SB 4-269-002

JANUARY 2008

SUBJECT: REVISED WIRE TERMINAL IN ALLISON TRANSMISSION WIRE HARNESS

Previous Terminal and New Terminal

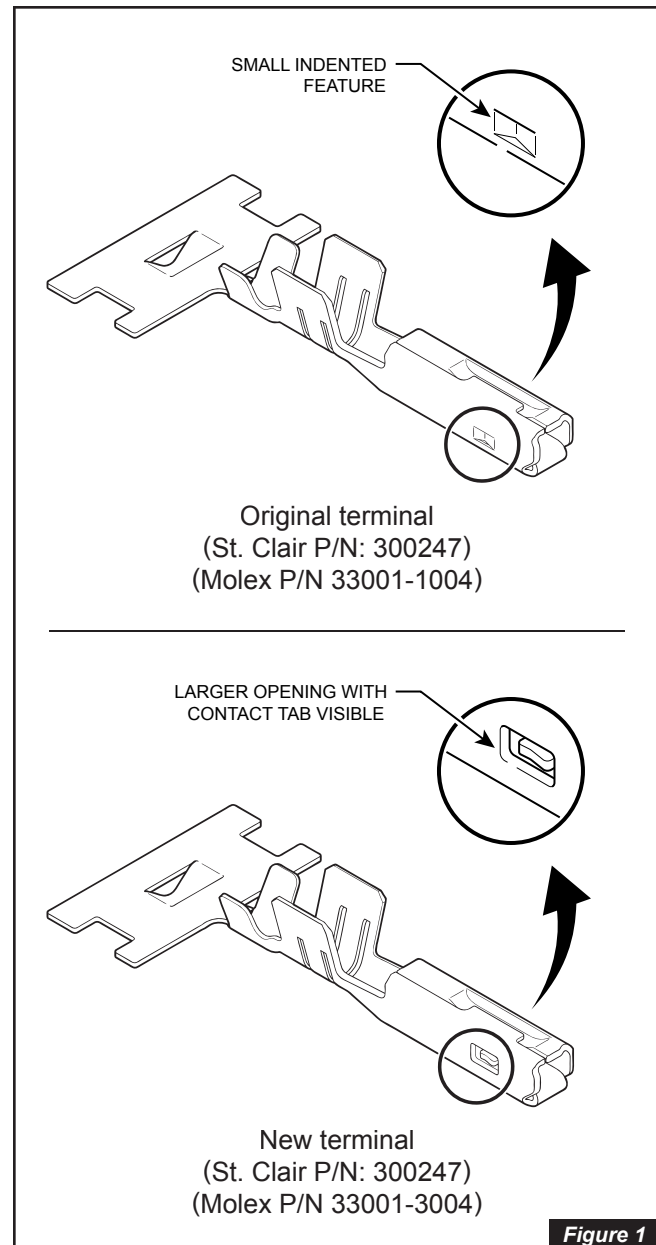
Figure 1 illustrates the former and current terminals. The most observable difference is the current terminal has “windows” on each side of the contact area and the spring member of the female terminal has “wings” which extend into the “windows” reaching to the outer surface on each side of the terminal. The former terminal has a dimple on each side in the same general area of the window. The metal from which the former terminal was formed was 0.25 mm (0.010 inch) thick and the metal in the current terminal is 0.30 mm (0.012 inch) thick. The additional 0.05 mm (0.002 inch) thickness of the metal requires a different crimping tool for the current terminal than for the former terminal.

Table 1 provides terminal and crimper part number information. Molex advises that the former terminal should only be crimped with the former crimper and the current terminal should only be crimped with one of the current crimpers.

Figure 2

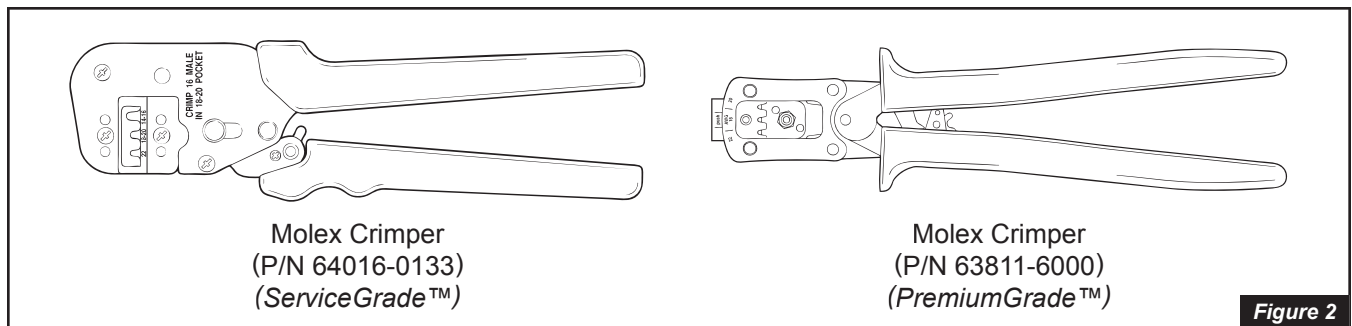
Figure 2 illustrates the crimping tools.

63811-6000 (*PremiumGrade™*): hand tool for 18-22 AWG MX150 terminal (ratchets)

64016-0133 (*ServiceGrade™*): hand tool for 14-22 AWG MX150 terminal (for field repair, ratchets)
